To: The Preserve at San Juan, LLC
c/o J.P, Weber Group
2697 N. Vista Glen Road
Orange, CA 92867

October 23, 2014

Project No. 12-054
Permit No. PA130026

Subject: Response to County Review Comments dated September, 2014, regarding the proposed Onsite Waste Water Treatment System, "The Preserve at San Juan" County of Orange, California

OTWS Setback Guidelines

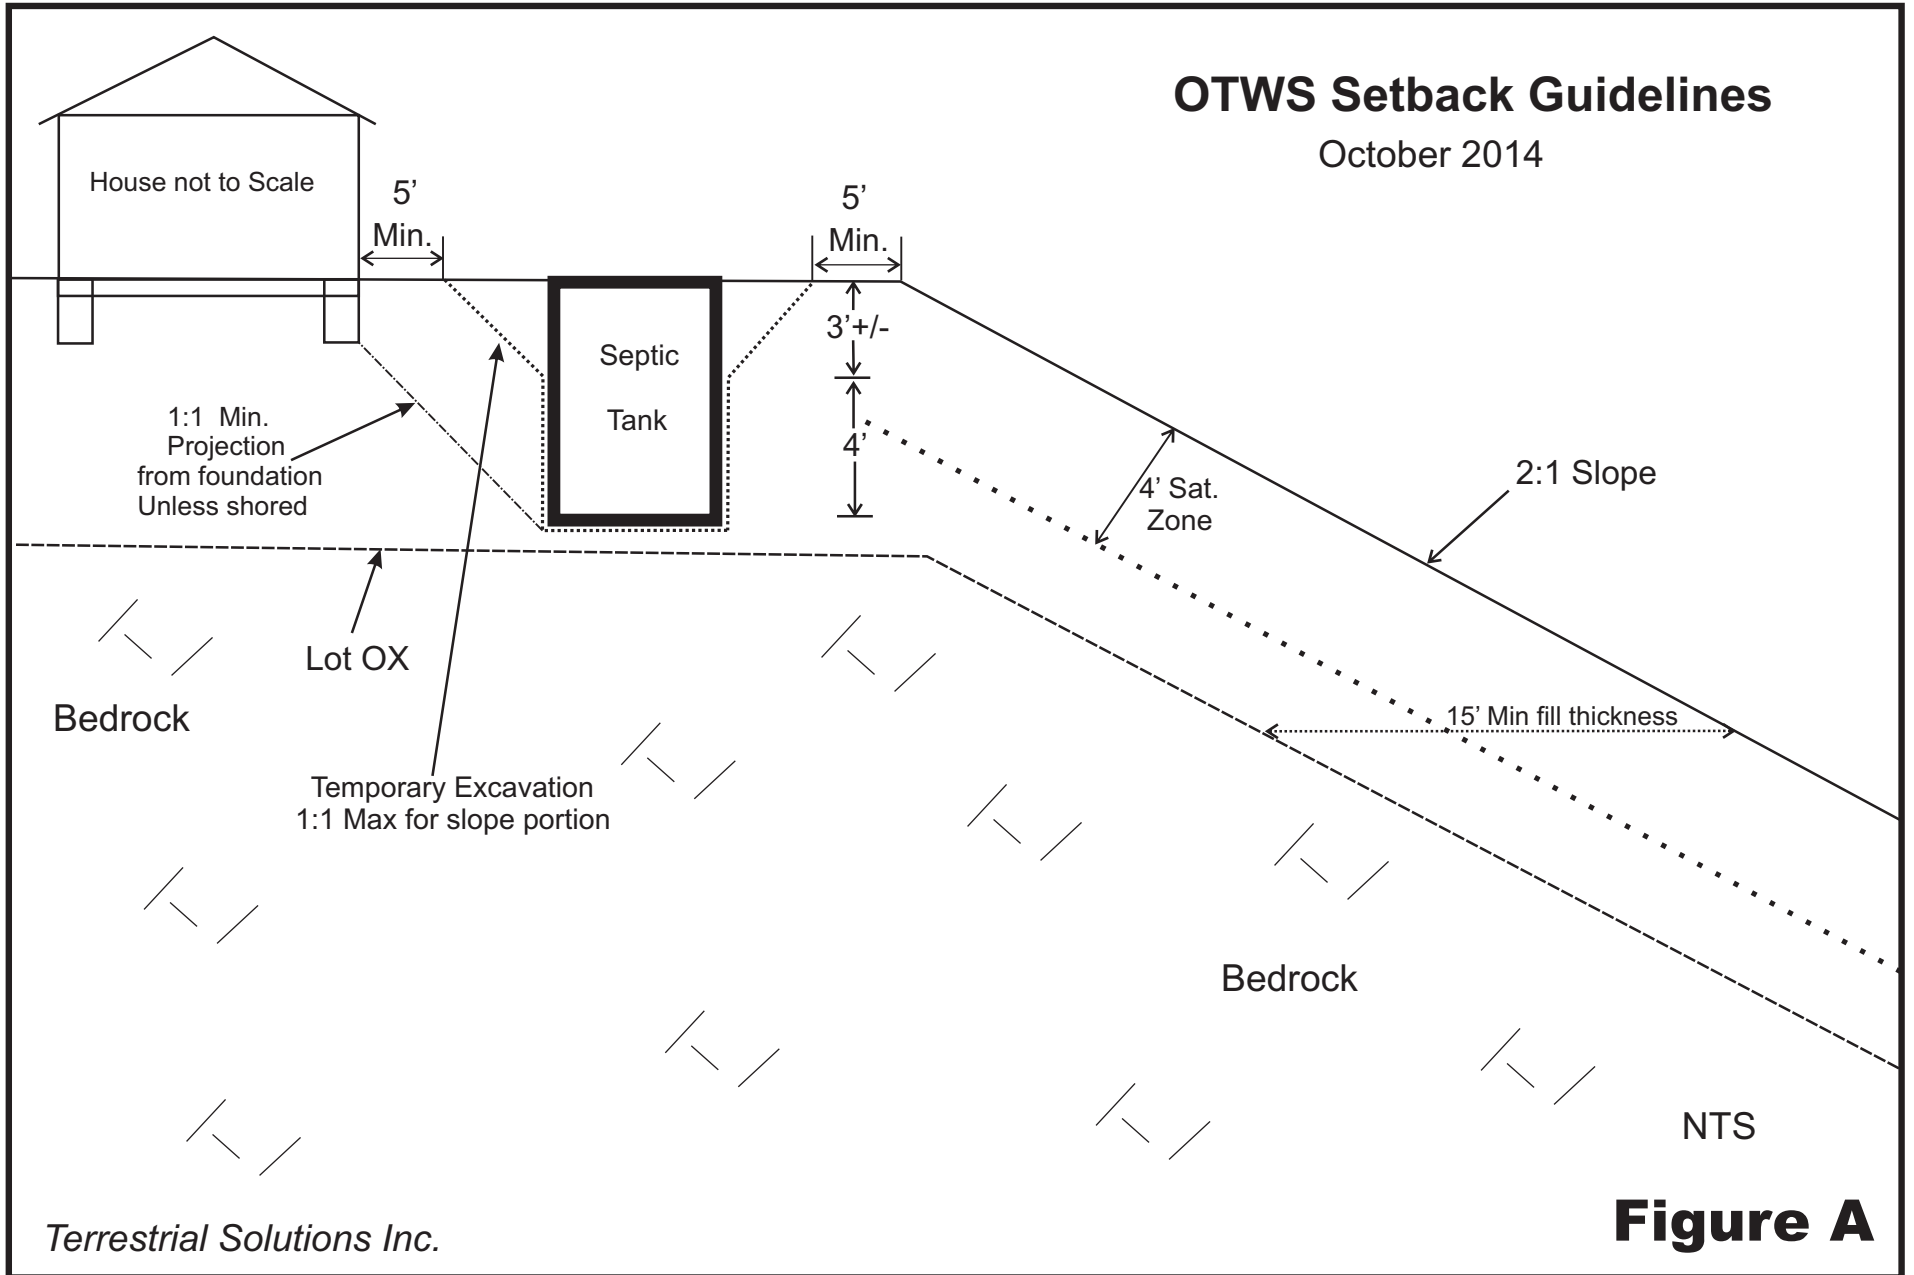
addition, the proposed OWTS will require a structural setback from the slopes and buildings. Please provide an updated standard excavation size required (length, width and depth) for installation of the septic tanks, pump tanks/boxes, biofilters and emergency overflow/extra capacity storage tank on a single lot at the subject site. The excavation description should include any appropriate temporary excavation recommendations required for system installation. Provide plot plan indicating the typical OWTS excavation size and currently proposed typical location at the subject site

62) *Provide typical drawing with minimum setbacks from foundations and slopes*

84) *Identify the setback distances from each OWTS unit to the residential units, fuel mod, WQ Basin, and drainage course in the site plan.*

TSI recommends that certain OWTS components (1,500 gallon septic tank, biofilters, and reuse water pump station/emergency storage tank) be setback a minimum of 5 feet from structures, property lines, and the top of descending slopes (See Figure A and Figure 1-PACE). These components do not emit water into the surrounding soils. Additionally, the bottom of these components should be located a minimum of 1:1 (horizontal:vertical) projection from the bottom of adjacent footings (See Figure A). The tops of the temporary backcuts for installation of the components should also be located no closer than 5 feet from existing structures and the top of slope. The intent of these setbacks is to allow for the installation and future maintenance of the components without negatively impacting adjacent structures or slopes during excavation and construction activities. Unsupported temporary slopes should be excavated in accordance with the regulations of the State of California, Division of Occupational Safety and Health, and County guidelines. It is anticipated that the OWTS components will be installed in engineered fill. For temporary cuts within fill, vertical cuts up to 4 feet can be made. Temporary excavations deeper than 4 feet should have a sloped portion no steeper than 1:1 (horizontal:vertical) unless temporary shoring is used (Figure A).

Response to Comment: Setbacks were discussed in the response to comment Number 29. Figures 1 (PACE) and A illustrates the required and recommended setbacks.

Response to Comment: See Figure A for required and recommended setbacks. Other requested setbacks are provided within documents provided by others.

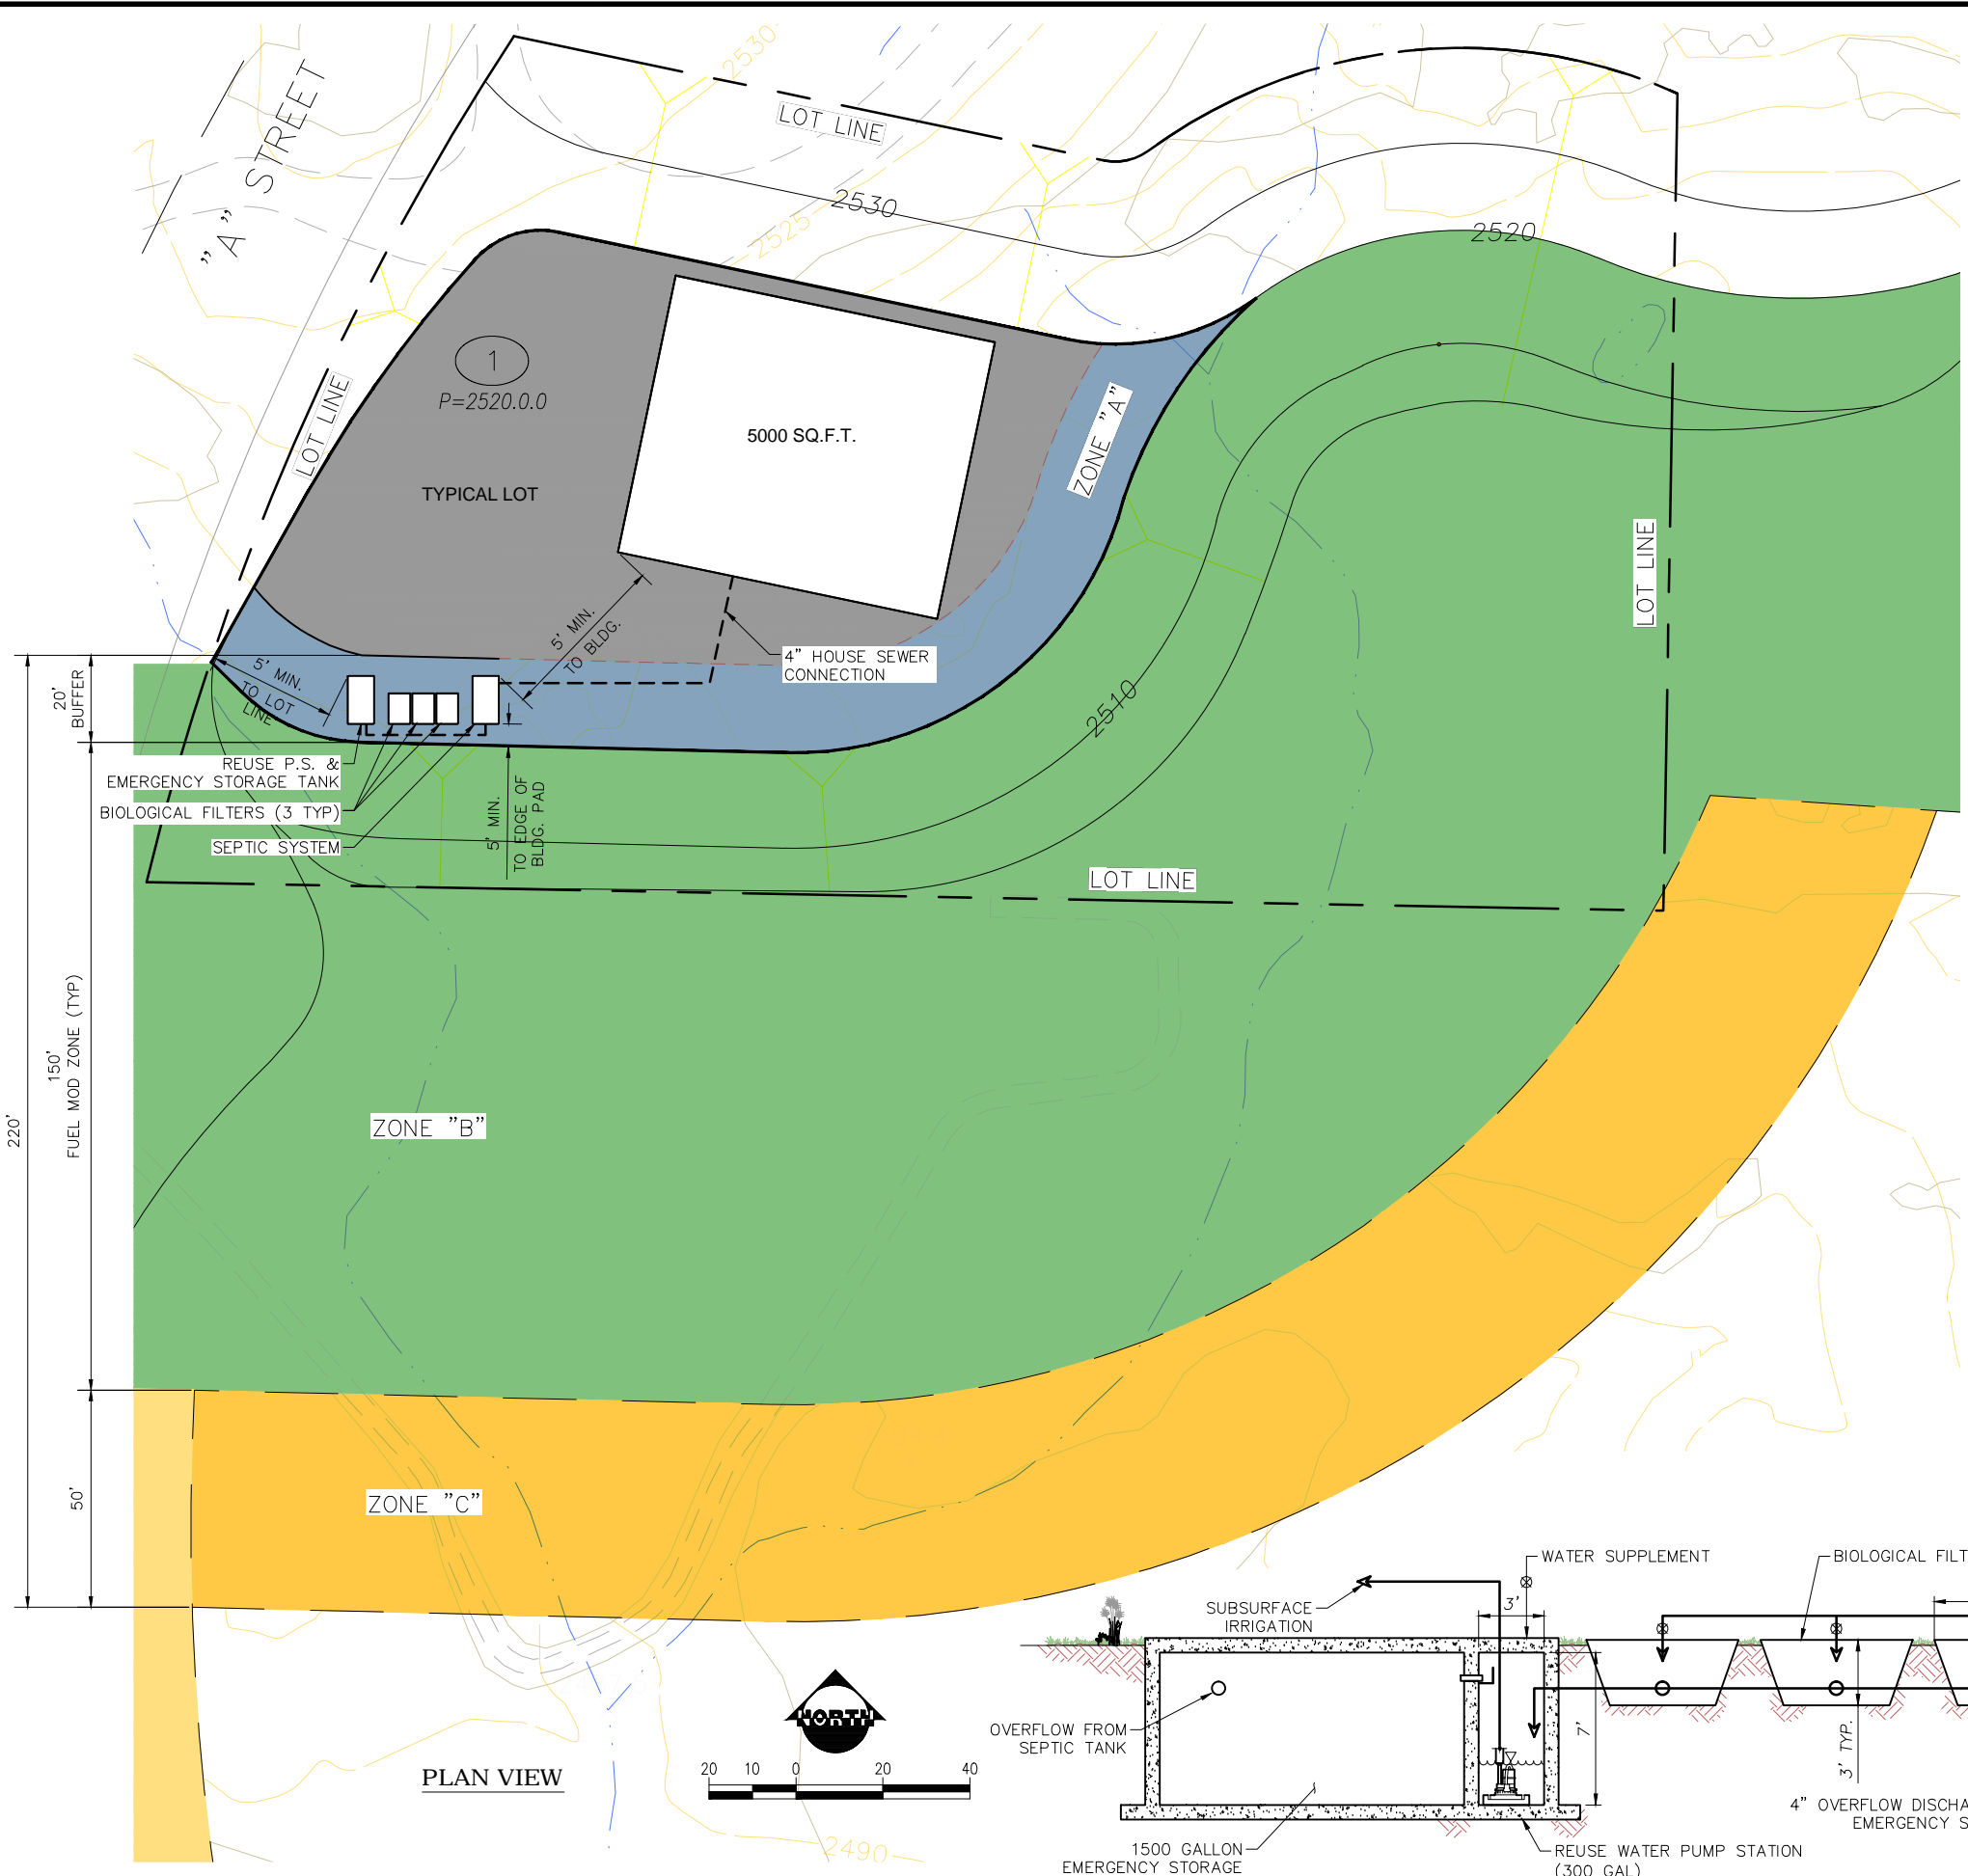
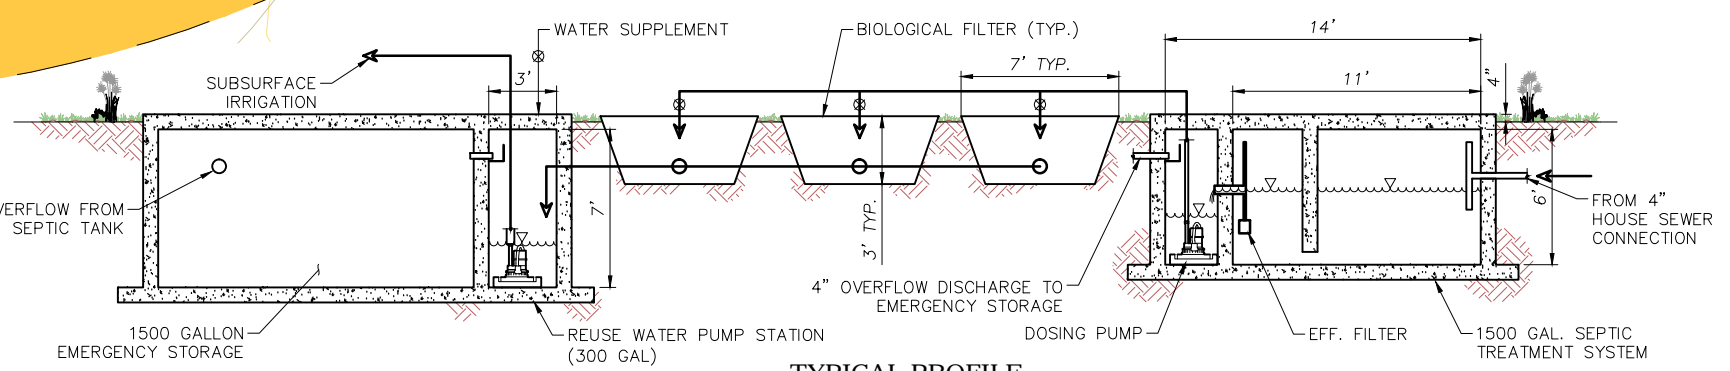
29) In lieu of the proposed drainage beds (mini leach fields) an additional storage tank for emergency overflow/extra capacity will be required as part of the proposed OWTS. In

83) *Provide a site plan to show the locations and layouts of the proposed Anua Puraflo Peat Fiber Biofilter OWTS (a proprietary product) in the project site.*

Response to Comment: In meetings on October 9 and 21, 2014, with County Planning and public works personnel, it was tentatively agreed that as an emergency contingency there would be additional overflow storage capacity built into the reuse water pump station. According to Figure 1 (PACE Advanced Water Engineering), a proposed 1,500 gallon emergency storage tank will be added to the 300-gallon reuse water pump station. Therefore, the dispersal field or mini-leach fields would no longer be necessary.

Response to Comment: See attached PACE Figure 1.

SURFICIAL STABILITY ANALYSIS

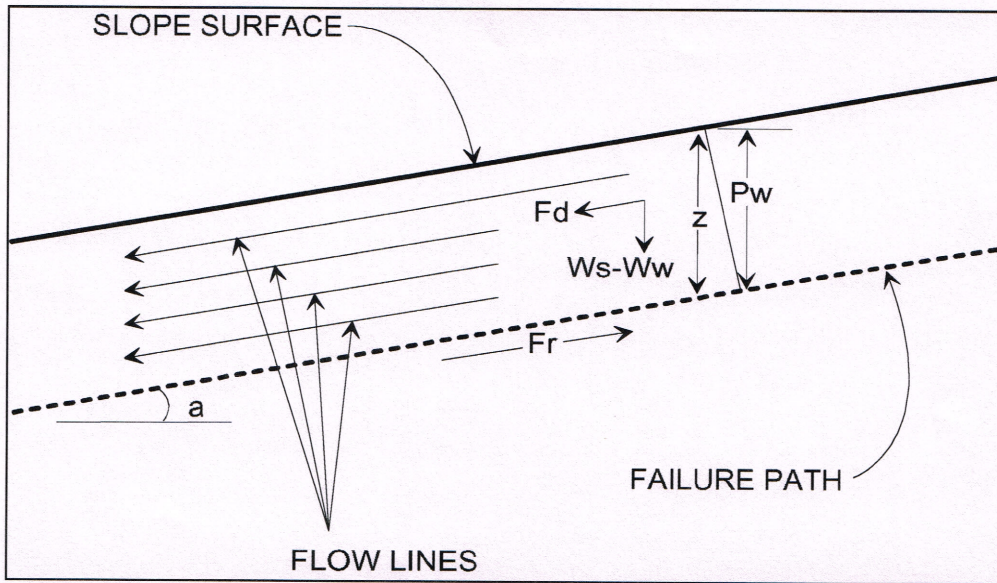
30) *Provide additional comment/discussion on short and long term impact of the proposed OWTS effluent dispersal emitters on slope stability (gross and surficial). Will the slopes (locally or globally) become oversaturated due to the proposed effluent dispersal? How will slope oversaturation be monitored? How will oversaturation of slope soils from climate oscillations impact the effluent dispersal? How will the wetting-drying cycle of slope soils from effluent dispersal, irrigation and climate oscillations impact slope stability? Provide additional recommendations as necessary. Include additional information (e.g. slope stability analysis, laboratory data, cross-sections, case studies, etc.) to support your conclusions/recommendations.*

64) *Introducing secondary effluent drip-system into manufactured slopes (during wet periods) could super-saturate these slopes and lead to surficial stability problems; also maintenance of slopes exposed to desiccation, the pipe clogging, etc. are issues to address.*

TSI conducted surficial stability analysis (infinite slope with seepage parallel to slope) on an engineered 2:1 fill slope assuming saturated depths of 5 and 7.5 feet (greater than the typical 4-foot maximum depth considered). Shear strengths and the density on

engineered fill soils was estimated based on the previous laboratory testing conducted by Pacific Soils Engineering, Inc. (PSE). The laboratory data developed by PSE was included in the previous prepared EIR document (TSI 2013) and has been appended herein as well. The results of the analyses are presented on Plates E-1 and E-2 indicate that the surficial stability of engineered fill slopes have factors of safety in excess of 1.5 (minimum factor of safety required by the County).
